ROCKY MOUNTAIN ARSENAL

FINAL  
SANITARY SEWER REMEDIATION  
INTERIM RESPONSE ACTION  
ALTERNATIVES ASSESSMENT  
VERSION 3.2

September 1988  
Contract No. DAAK11-84-D-0017

RESPONSES TO COMMENTS OF  
COLORADO DEPARTMENT OF HEALTH  
SANITARY SEWER REMEDIATION  
DRAFT FINAL INTERIM RESPONSE ACTION  
ALTERNATIVES ASSESSMENT

PLATE 1

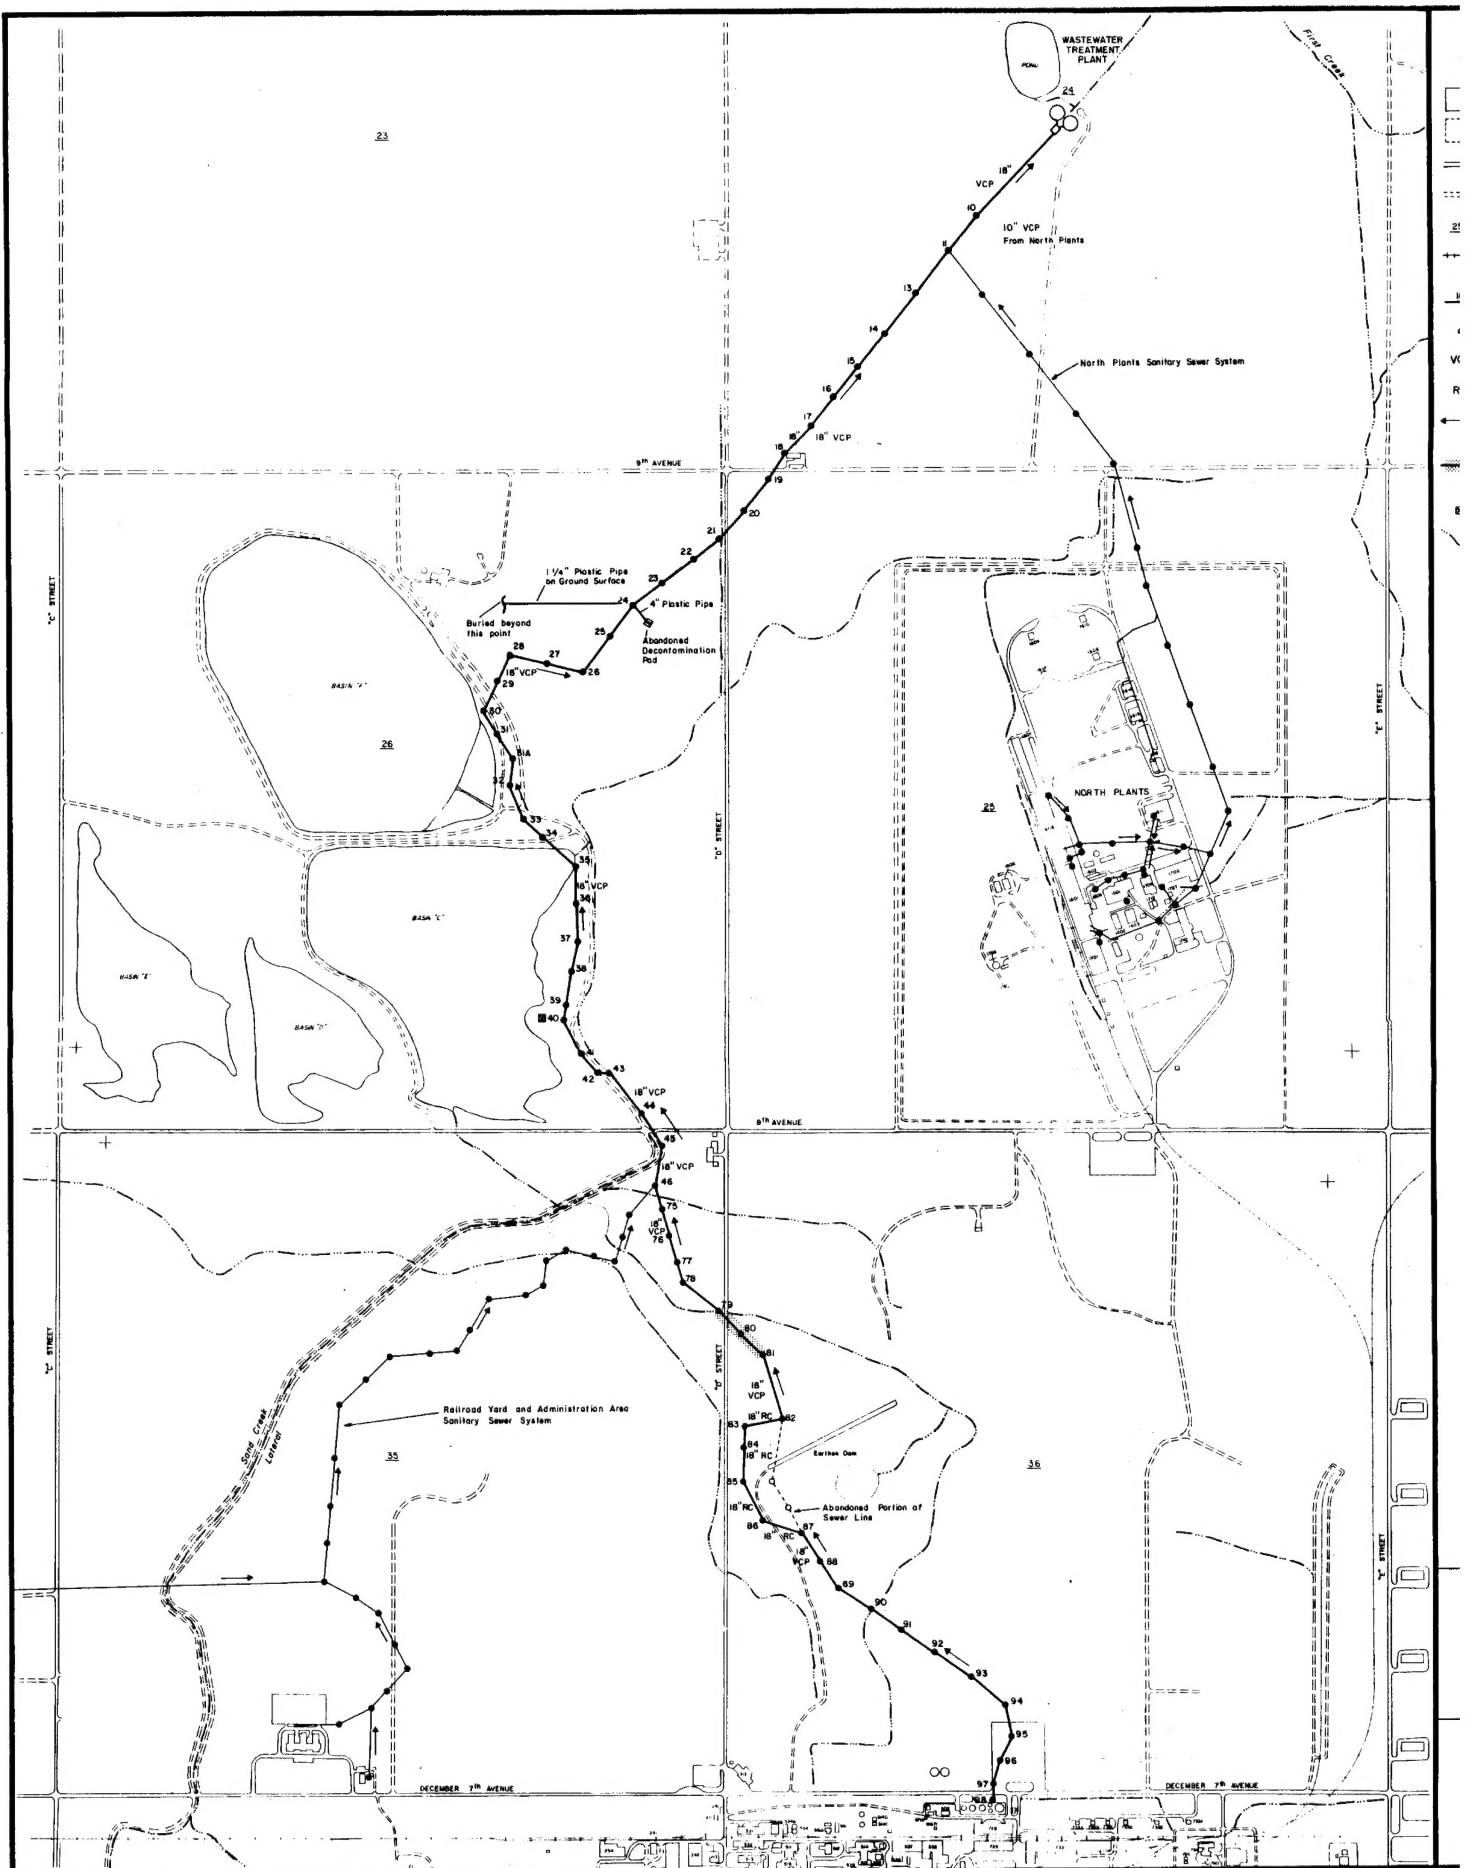
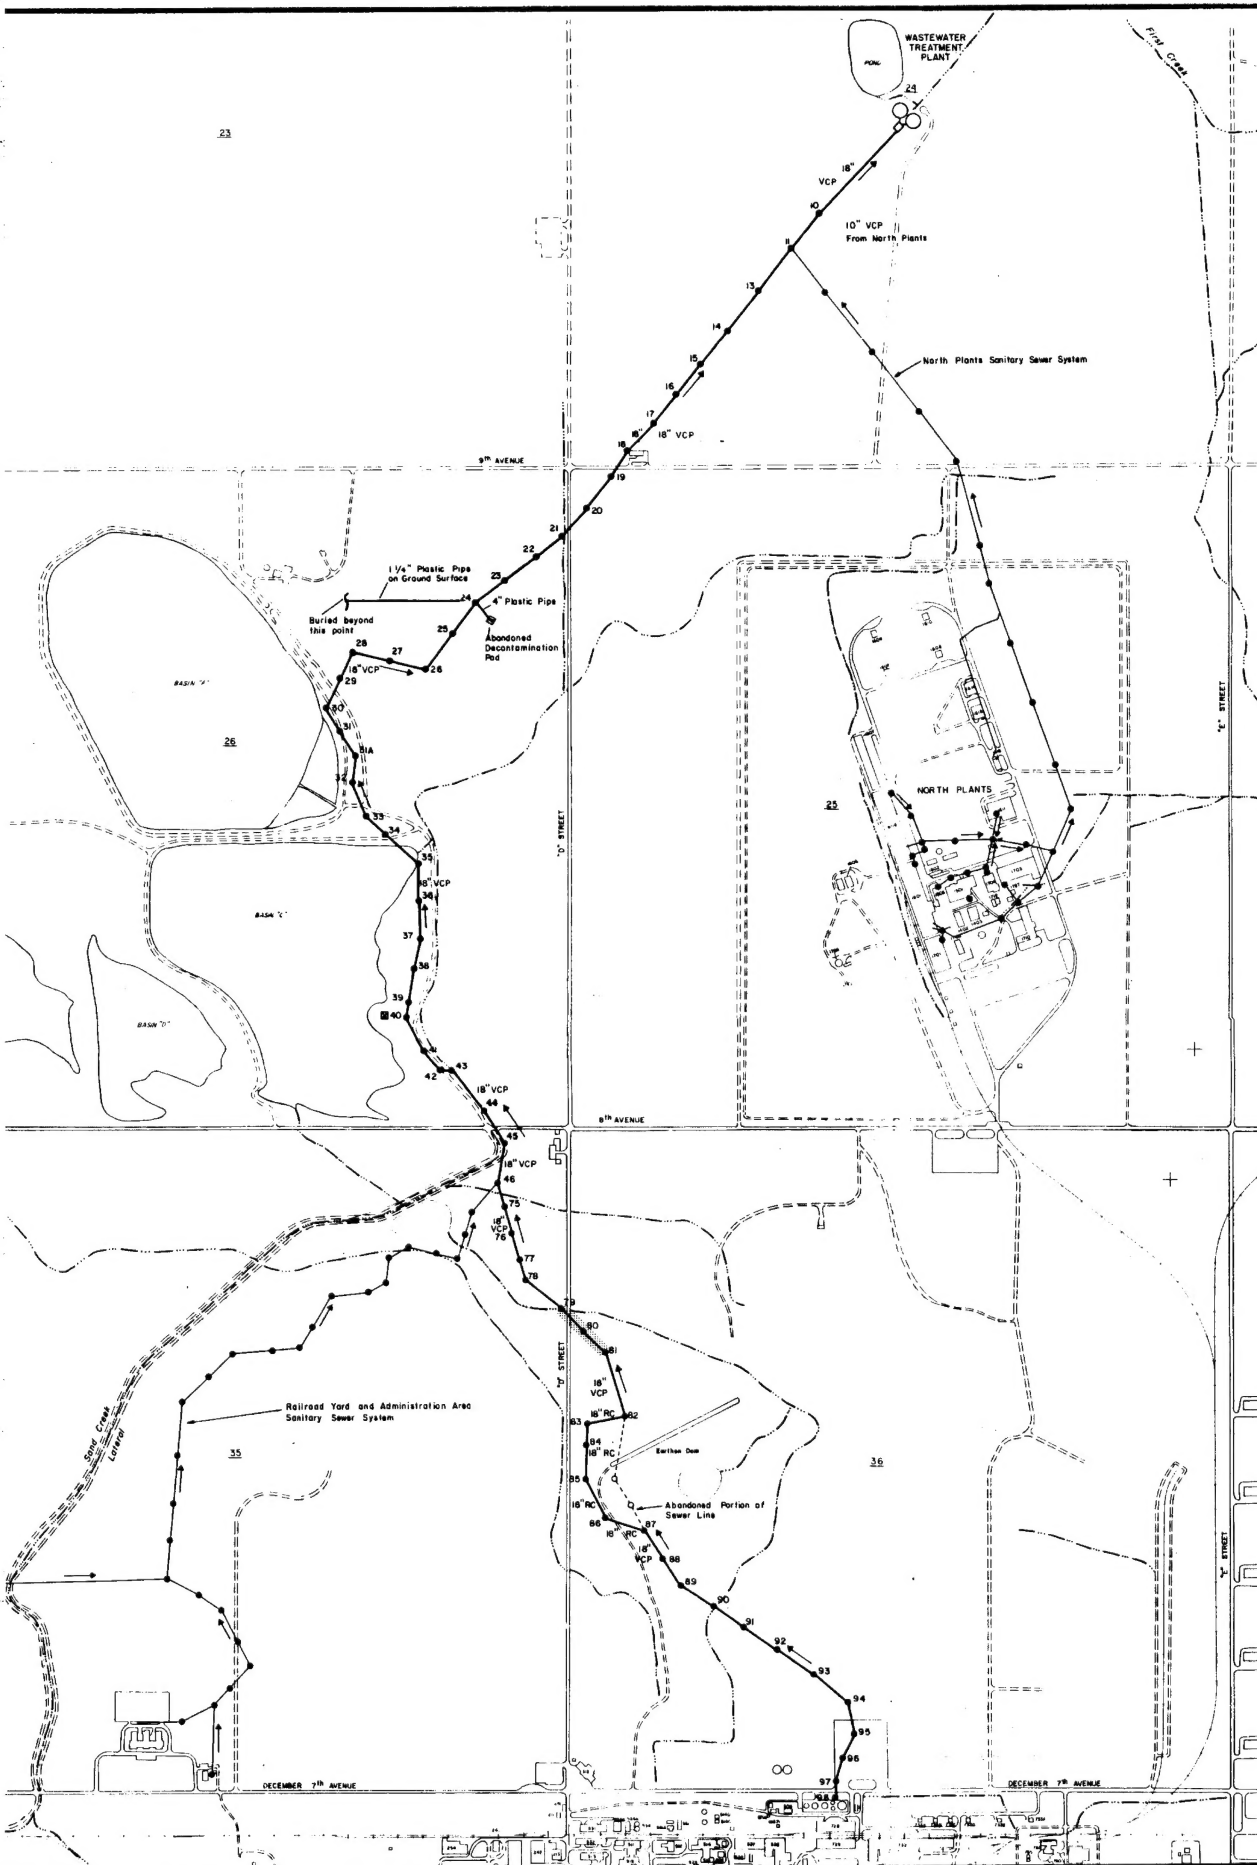
**Comment 8:**

Plate 1: The plate has been revised to correspond to the text on page 5, where it is stated that Black and Veatch noted heavy infiltration between Manholes 101 and 103. Additional infiltration may be taking place, but this is the only section for which supporting documentation has been found.
